To;- Toronto and East York Community Council

Re Agenda Item Number TE34.38 Meeting July 4th 2018

Application # 160255319 STE 22 OZ 33 Rosehill/44 Jackes Ave Site (Bretton Place)

1.Applicant Ground Floor 2.Applicant Proposal Level 2. 3. BPTA Tower Proposal

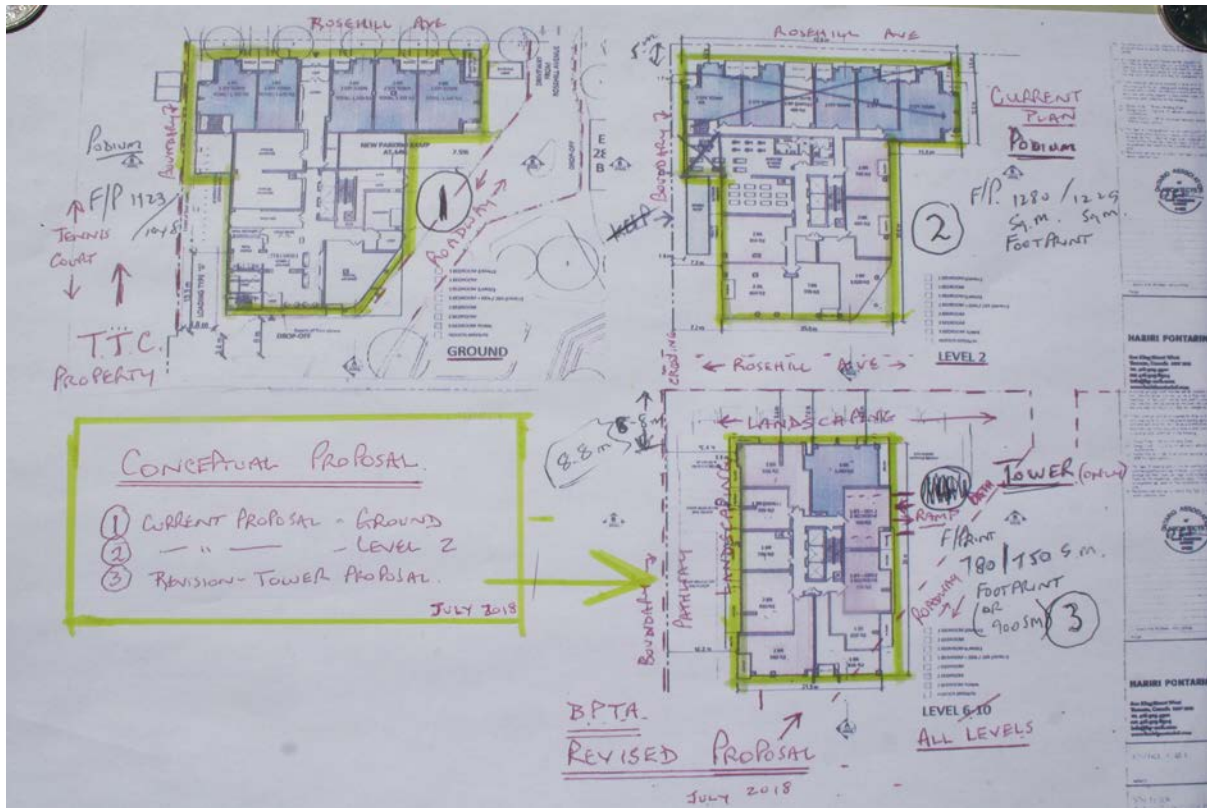
- 1. **Footprint/Setbacks**..... The overwhelming footprint on this essentially triangular site with roads on two sides and leased property on the West side is a source of great concern.
We would wish to see the footprint, currently 1123 Sq M, and the 1280 Sq M. Level 2 overhang, both be reduced to allow for better preservation of site character, pedestrian-safe pathways, landscaping and increased treed setback. Alignment with adjacent 33 Rosehill Ave would be desirable and practical.

- 2. **Podium/Townhouses**... We request elimination of this feature (see Page 1). The current application adds to using up the bulk of the site, causes potential pedestrian safety issues and virtually eliminates any worthwhile greenery. Concerns for wind appear overblown and not a problem in the immediate area. Incorporating town houses in the plan are a safety problem along Rosehill Ave.

- 3. **Tower Mass / Height**..... We ask that consideration be given to limiting tower height to match the height of 33 Rosehill Ave (84 metres) in such a way as to accommodate an economically viable number of residential units.

We are proposing a 27-storey Tower with no Podium/Town Houses and a height of 84 metres to align with and match the adjacent 33 Rosehill Ave, via a 50/50% mix of ceiling heights of 8ft/ 9 ft. (Projected concept numbers are estimated+rounded).

**Version 1 . A 900 Sq.M per floor Tower with a potential of 275 units.
27 Storey. 24300 Sq M. (vs 22880 Sq M) Density 1.92 vs. 1.81**
OR
**Version 2 . A 790 Sq.M per floor Tower with a potential of 225 units.
27 Storey. 21330 Sq M. (vs 22880 Sq M) Density 1.66 vs. 1.81**
